**6.2** **103 BEACH STREET PORT MELBOURNE**

**EXECUTIVE MEMBER:** **KYLIE BENNETTS, GENERAL MANAGER, CITY GROWTH AND DEVELOPMENT**

**1. PURPOSE**

- 1.1 To determine an application to amend a planning permit to redesign the building, add an additional storey (resulting in a five-storey building), increase the number of dwellings from 12 to 22, modify the façade and building envelope, delete the food and drinks premises and increase in the floor area of the supermarket, add an additional level of basement with an increase in parking provision from 30 to 51 spaces and internal changes.

**Fig 4:** Graphical representation from the submitted Design Response showing the surrounding built form context

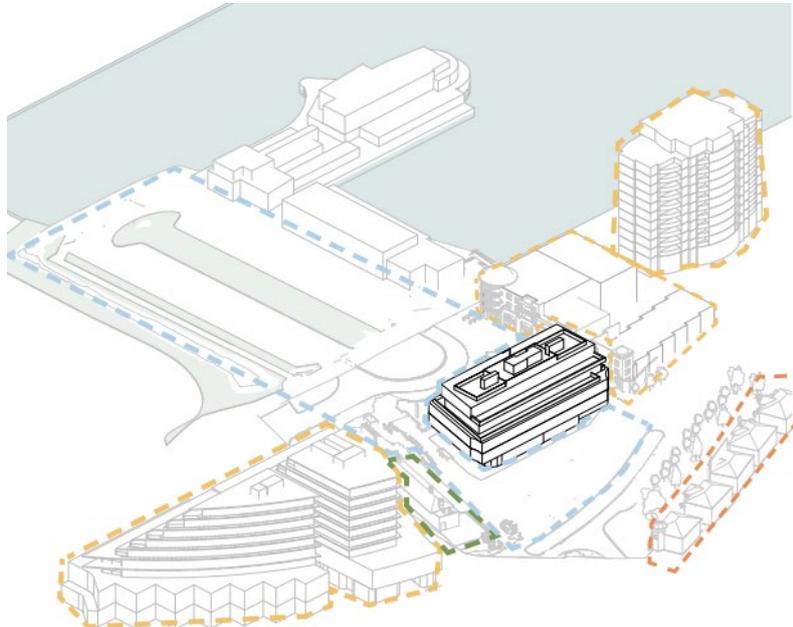
- 14.28 This graphical representation of the surrounding area illustrates that the Carr Architecture proposal would be a comfortable fit with the surrounding area. The diagram shows that the proposed building would have a height that is comparable to the built form to the west and be compatible to the larger buildings that are existing or are to be developed nearby. It also importantly shows that a large and clear separation would be provided from the lower scale residential area to the north. This ensures that there would be no adverse impact on the character of the residential precincts of Beacon Cove.

- 14.29 While the overall concept of the five storey building is supported, planning officers are concerned that the setbacks to the upper levels do not adequately address off site amenity impacts. Planning Officers agree with the comments from Council's Urban Designer that the shadows cast from the additional levels would be reasonable. The submitted shadow diagrams show that there would be no additional impact to adjoining balconies and would not affect the key public realm spaces of the Bay Trail and Waterfront Plaza. However, there are concerns in relation to the visual bulk that would be created from the upper levels.

- 14.37 Subject to the requirement for additional setbacks to level 3 and 4, the proposed increase in height is considered an acceptable change for the amendment application.

**Fig 7:** Cut out of the original Key Infrastructure proposal which shows the existing car park has spaces within the title boundary of the subject site.

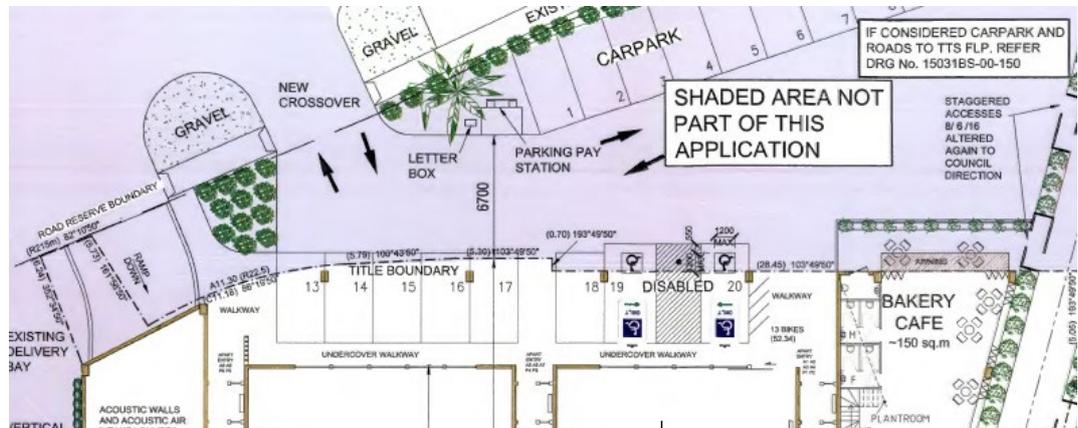
- 14.49 What has not been so successful is the impact of the two previous approvals, (Key Infrastructure and Wood Marsh) on the public areas to the south and the north. In particular, the two previous approvals did not resolve how the car park to the north would be modified to allow for the construction of the new building on the subject site but retain a functioning car park.

- 14.50 There is a significant issue for the existing car park where the spaces along the southern side of the car park are partly located within the title boundary of the 103 Beach Road site. This is shown in the plan below which is taken from the plans for the original Key Infrastructure application. This was a key consideration of the approval of the application.

- 14.51 For the current approval (Wood Marsh) the endorsed plans sought to resolve the car parking issue by providing an indicative layout of how a car park will still be able to be provided on the land to the north of the subject site. However, the planning permit that was issued did not include any final design for the car park or any means how the redesigned car park would be constructed.
